*STP-209-1(2) Roadway and BHF-209-1(3) Bridge  
Widening of SR 74 From SR 85 to*

*P.I. Nos. 322355 and 322357*

**Value Engineering Study Report**

Preliminary Design Stage

ALTERNATIVE No.  
21  
ORIGINAL DESIGN  
AND  
ALTERNATIVE DESIGN  
SHEET 2 OF 5

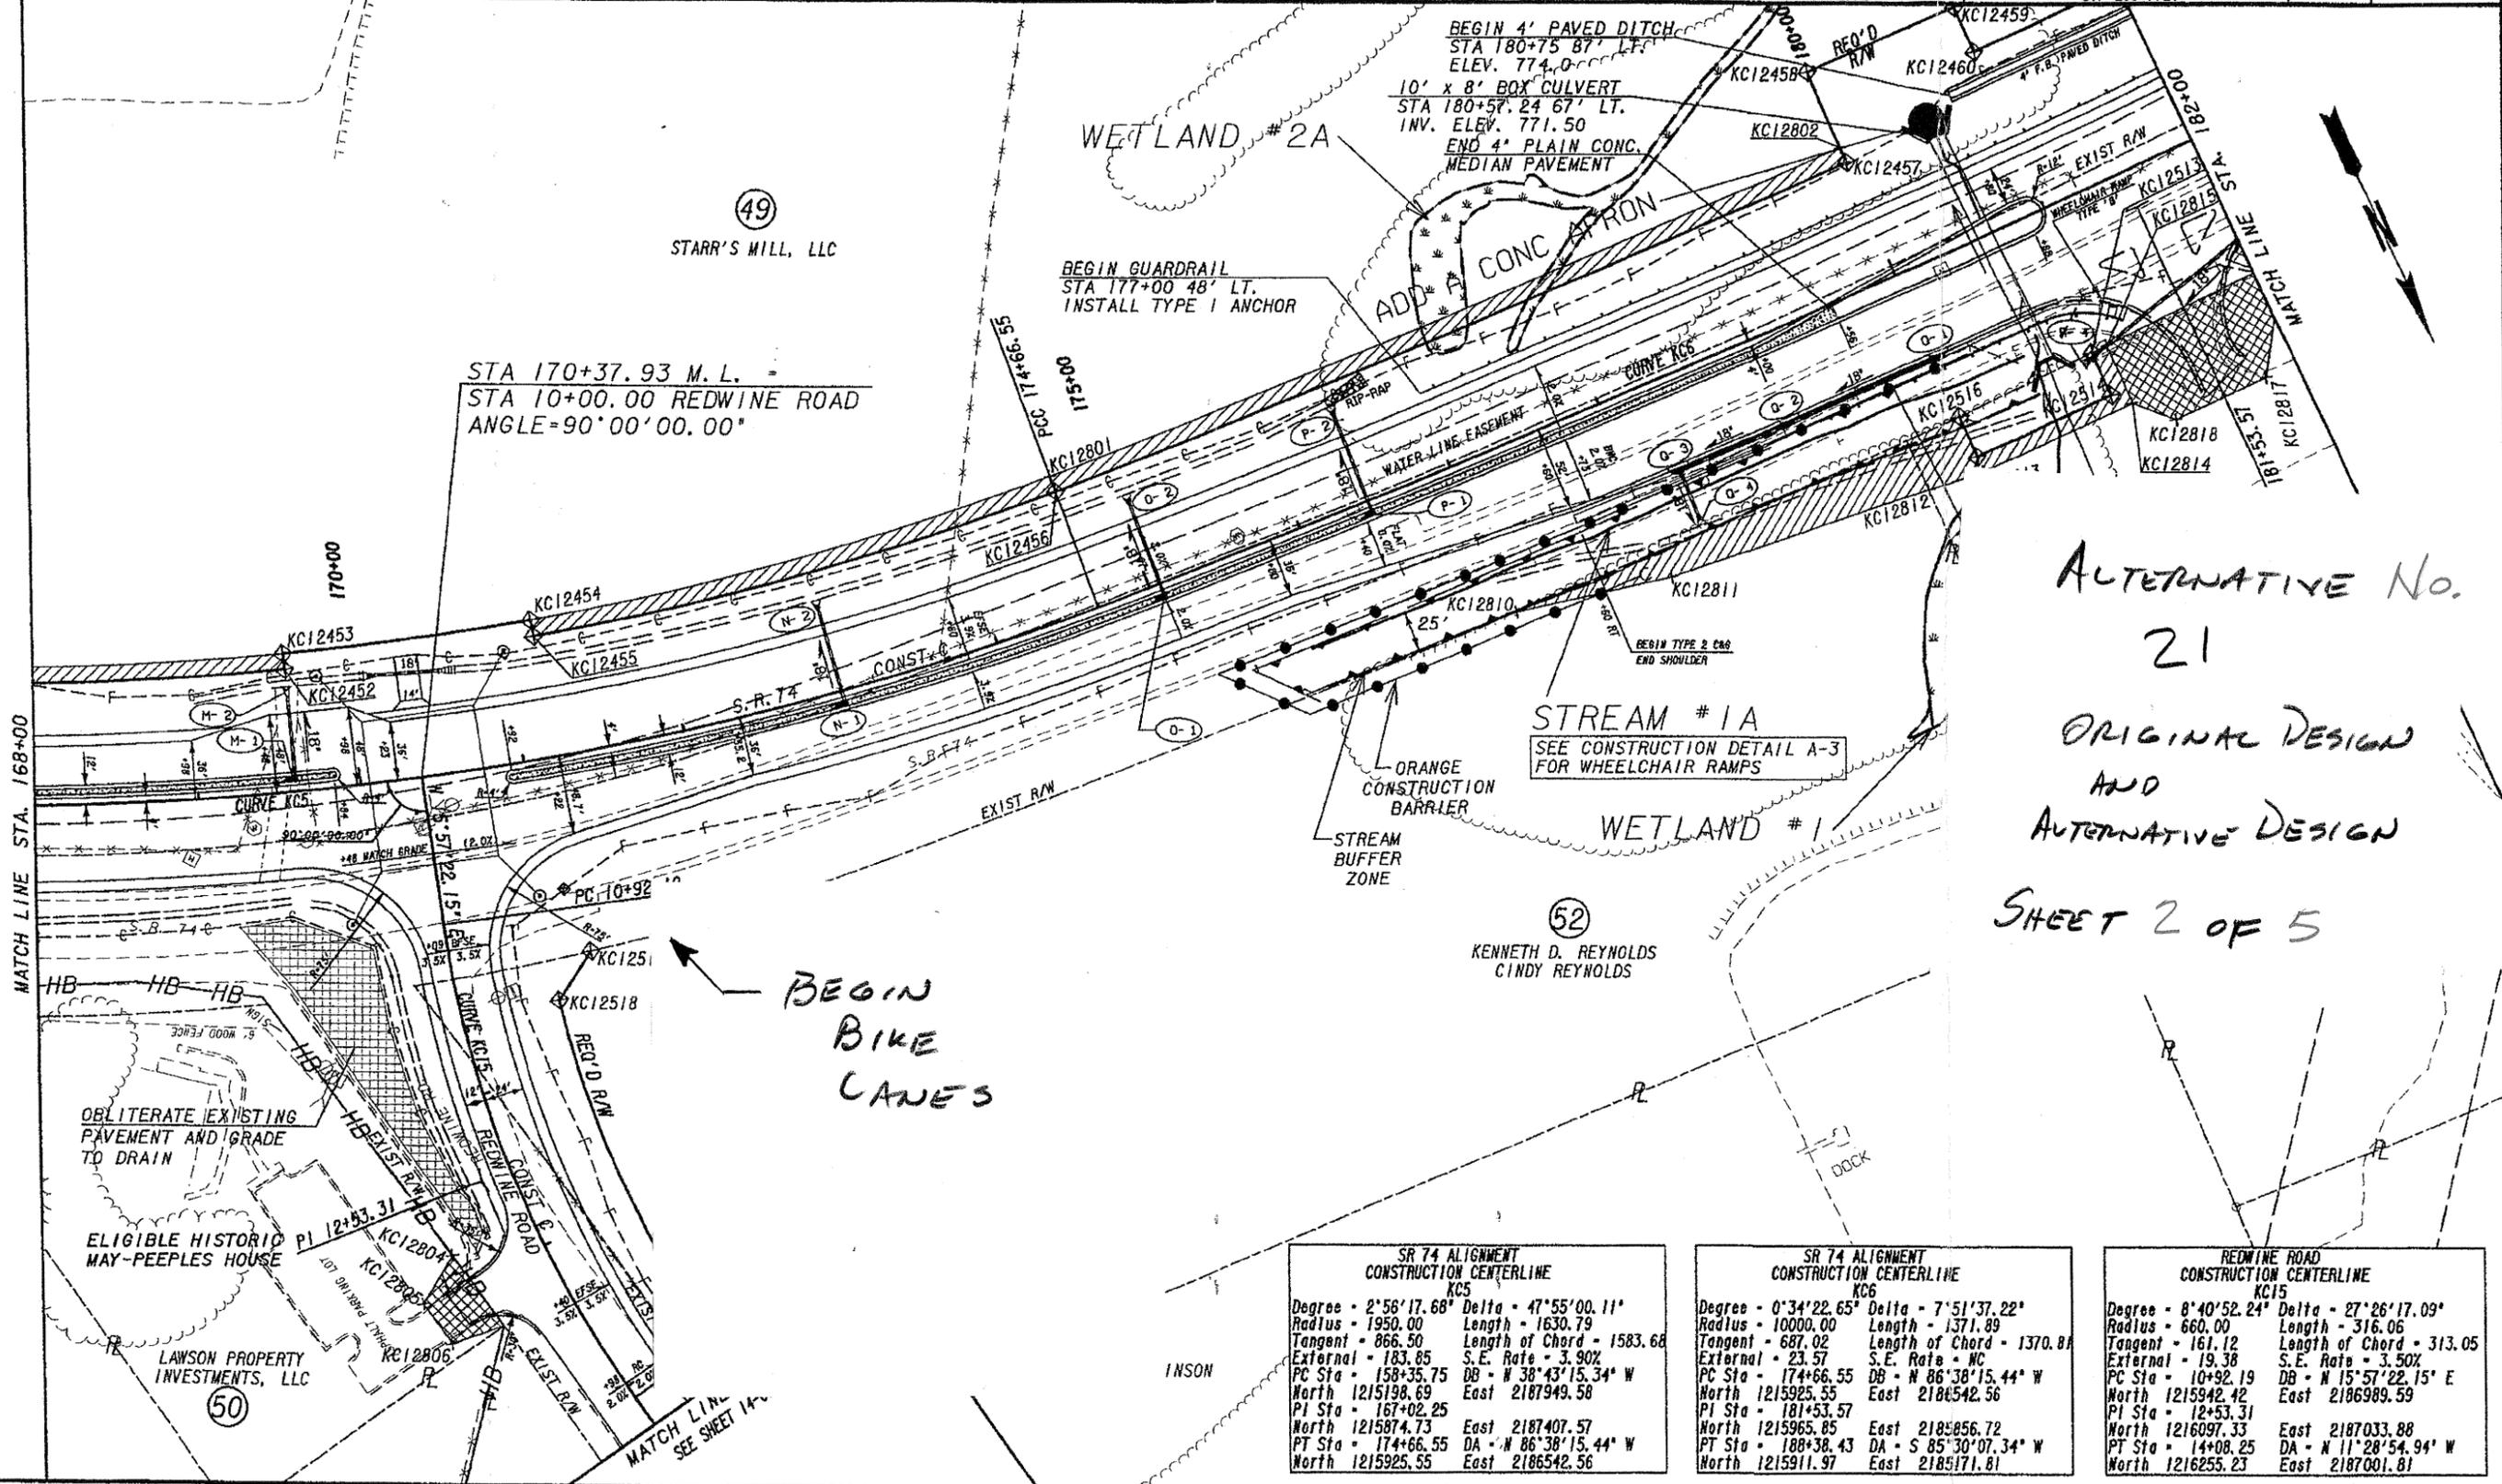
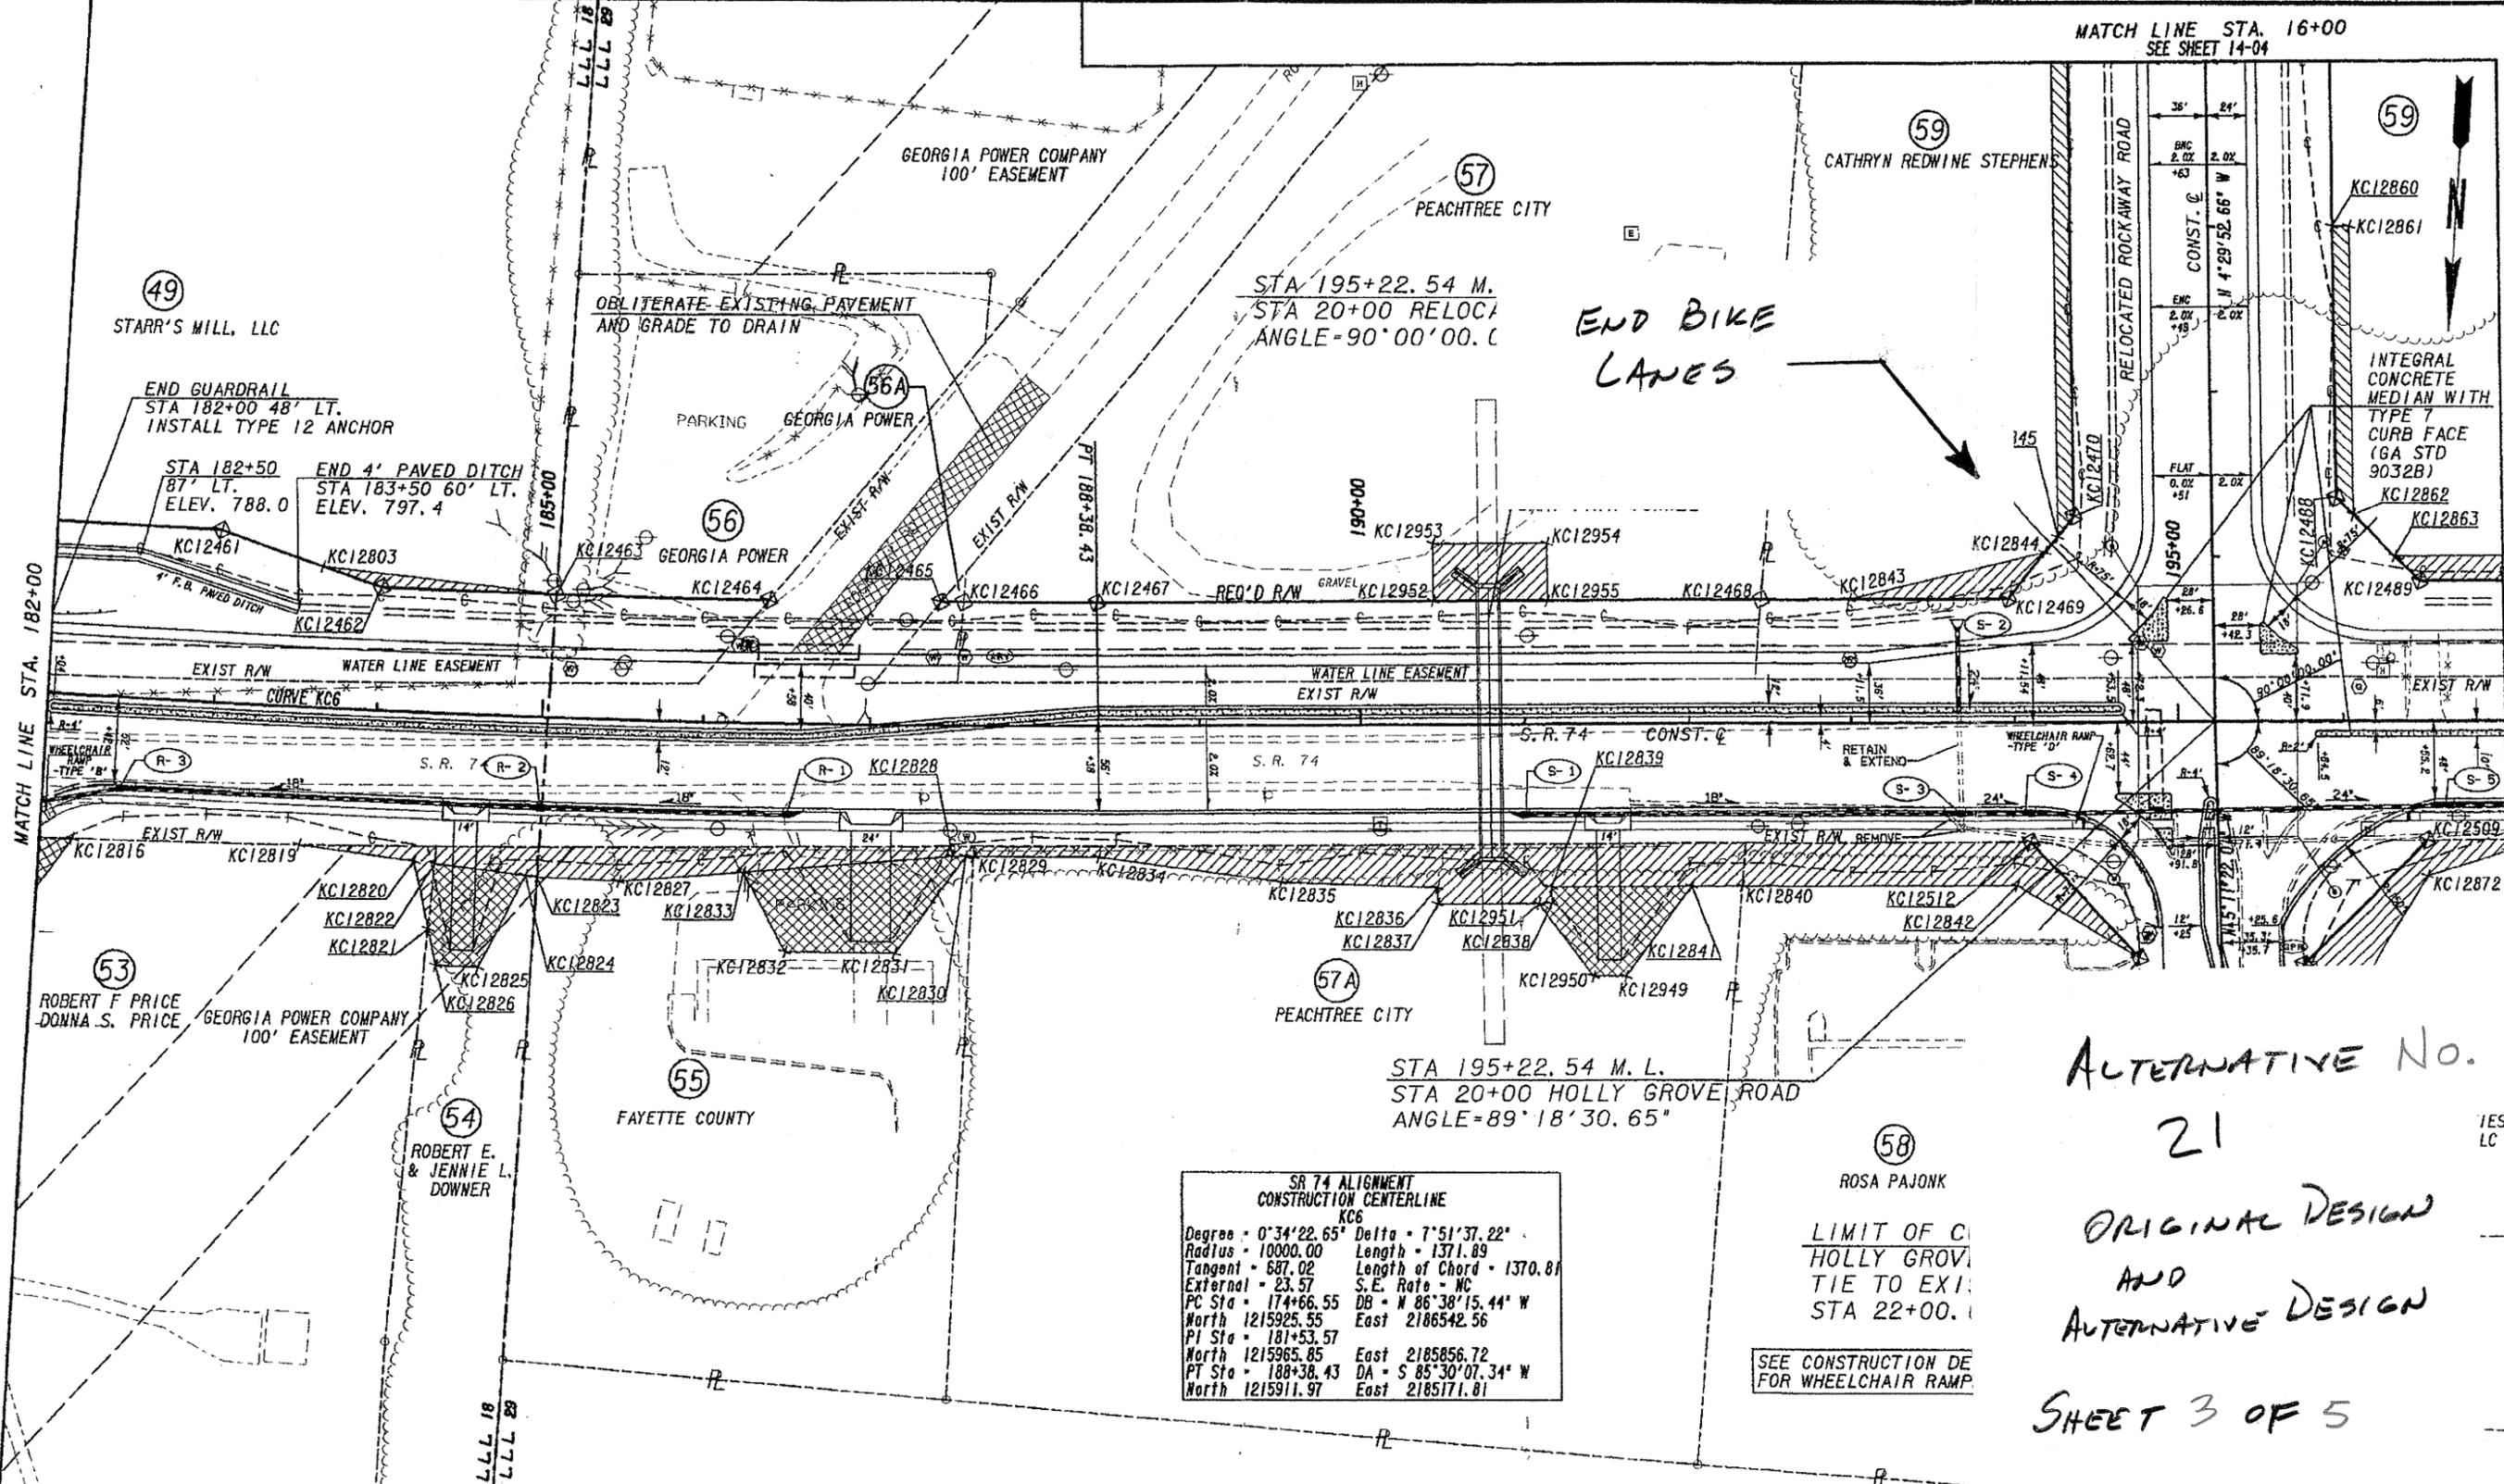
DESCRIPTION: **ELIMINATE THE BIKE LANES AND PROVIDE A MULTI-USE WALKWAY** SHEET NO.: **1 of 5**

REMOVE 4' OF BICYCLE LANE ON EACH SIDE  
OF SR 74 FOR 2350 FT.

ALT. NO. 22  
Sht. 2 of 4

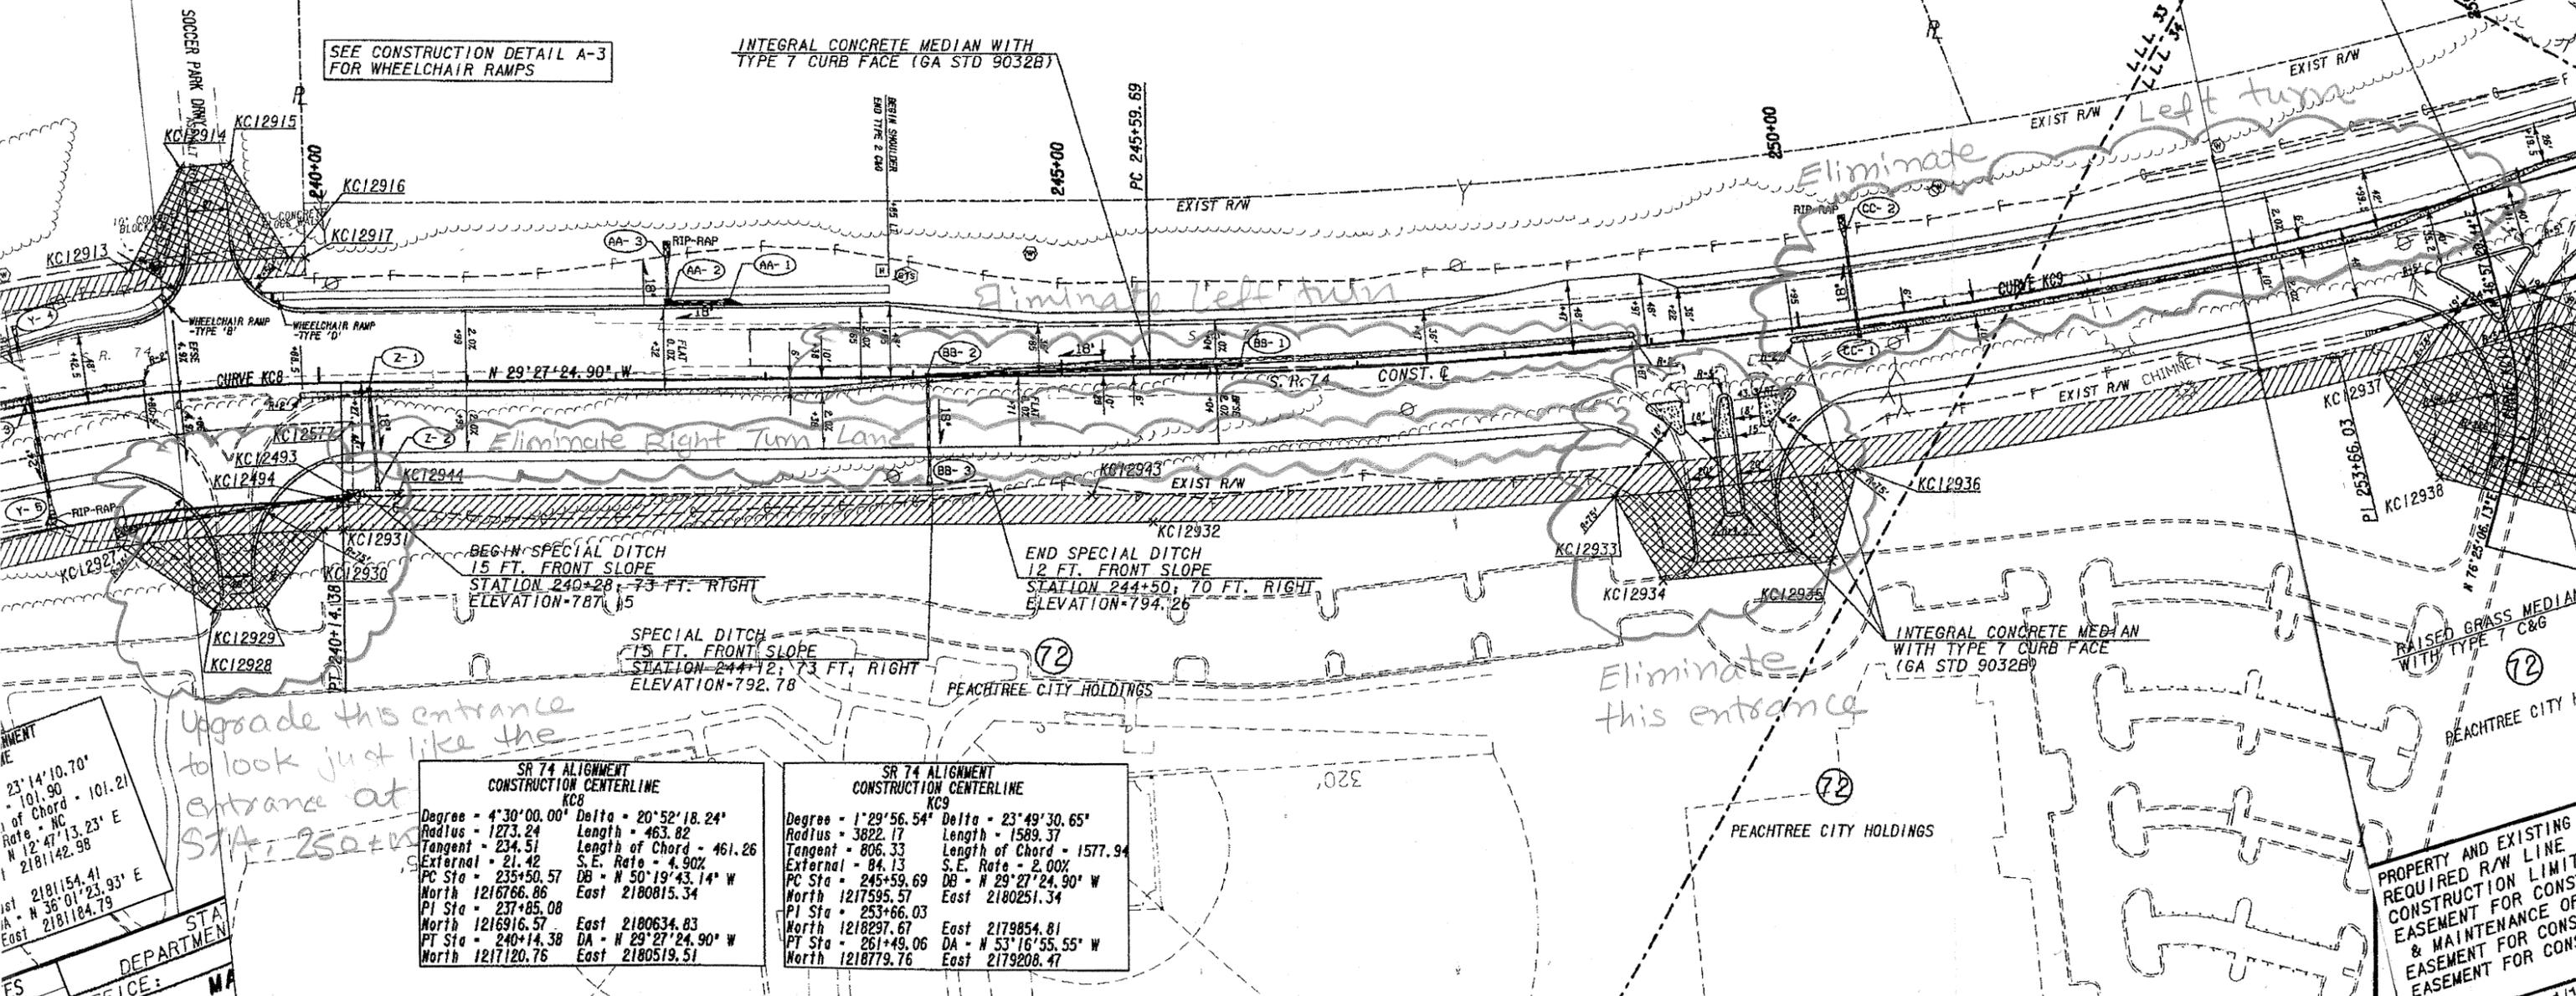
A two-lane entrance is show at Sta. 240+00. The width is 24 ft. At Sta. 250+00, the entrance to the baseball fields is 54 ft wide with concrete islands channeling the traffic. Both entrances have left turn lanes on SR 74.

Calculations show a cost savings as a result of eliminating the left turn lane at Sta. 250+00 and removing the entrance at Sta. 240+00. Since the entrance at 240+00 is proposed to be exactly the same as the entrance at 250+00, no calculation is shown for the elimination of entrance at 250+00.
